## MEMORANDUM

To:	Mr. David Swisher	Date:	January 6, 2011
Copy To:	Bill Mercer, Rick Hoos	File No.:	NB101-390/2-A.01
From:	Matthew Parfitt	Cont. No.:	NB11-00008
Re:	Thor Lake Project – Pine Point Hydrometallurgical Site Clarification

P/A NO. NB101-390/2	REF NO. NB11-00008
FIGURE 3	
REV 0

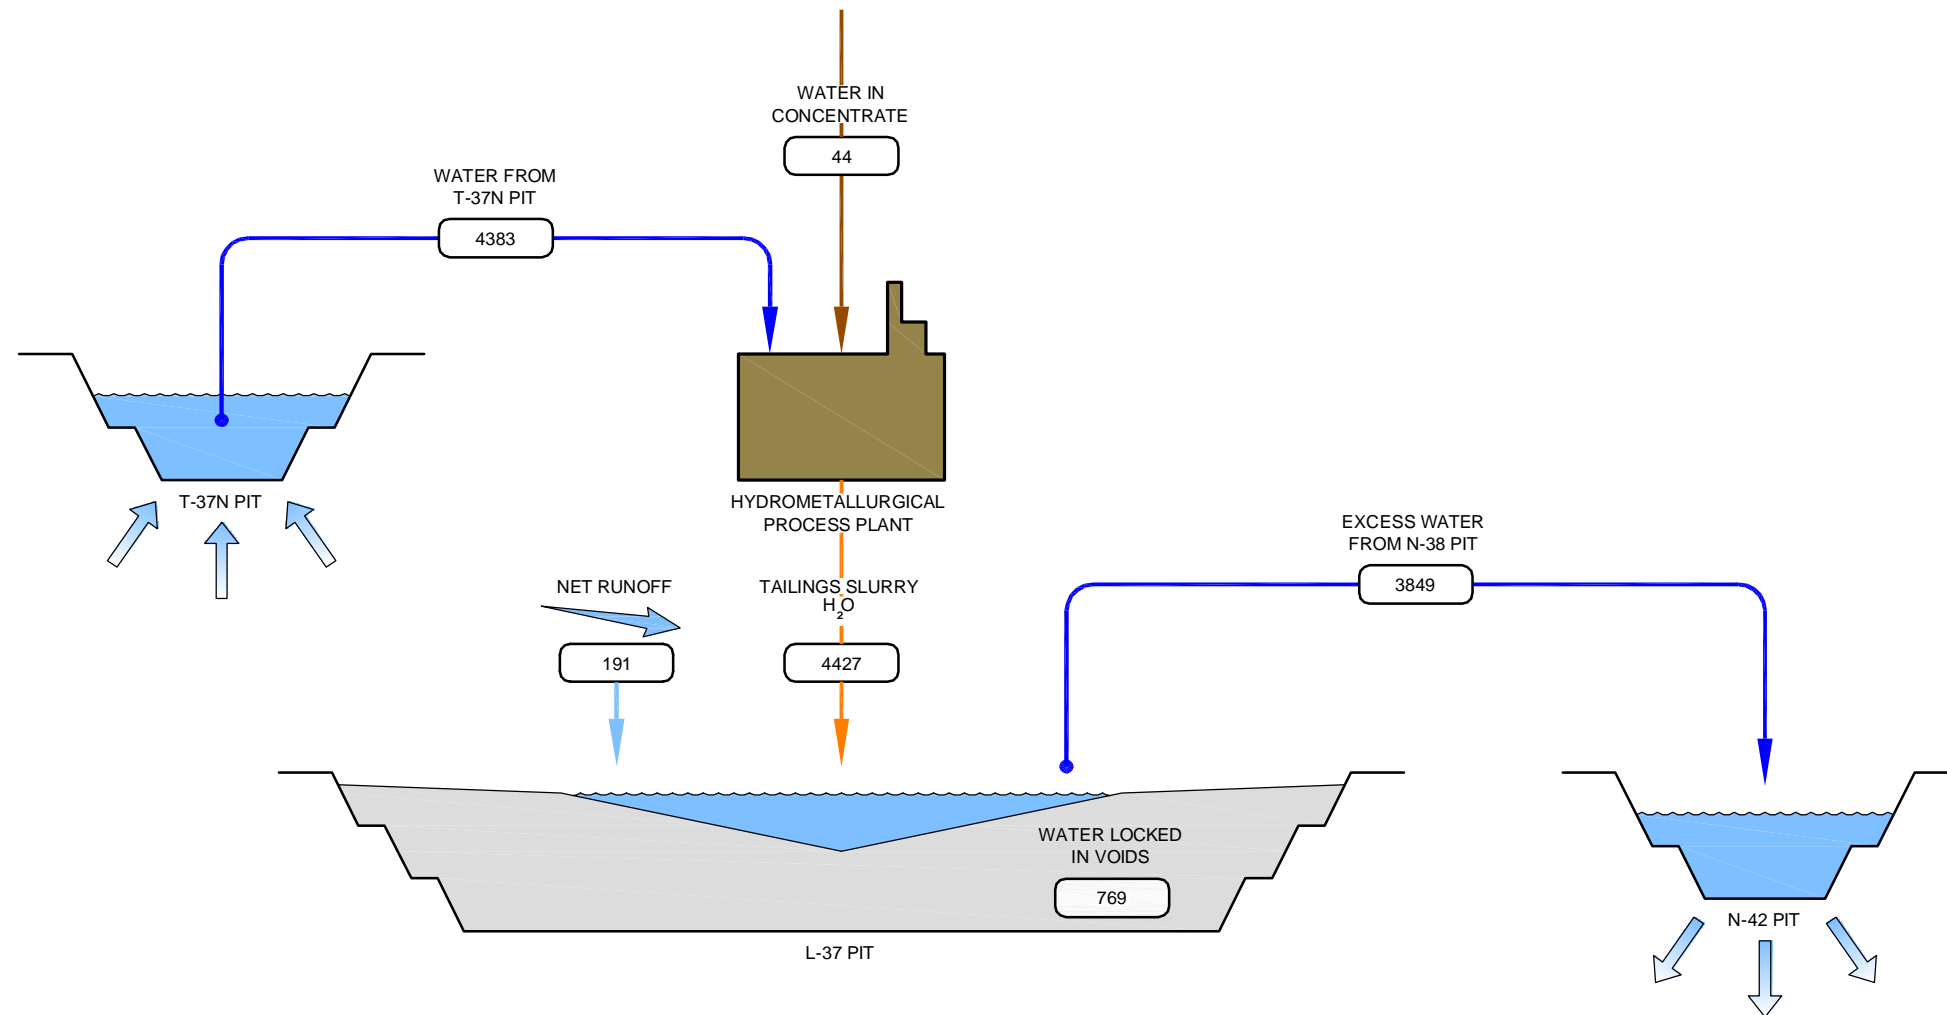
A revised general arrangement has been developed for the Pine Point Hydrometallurgical Site layout as shown on Figure 2 as well as a revised preliminary water balance flow sheet (Figure 3) based on the clarification and changes noted above. This layout arrangement will be used for development of the project design moving forward.
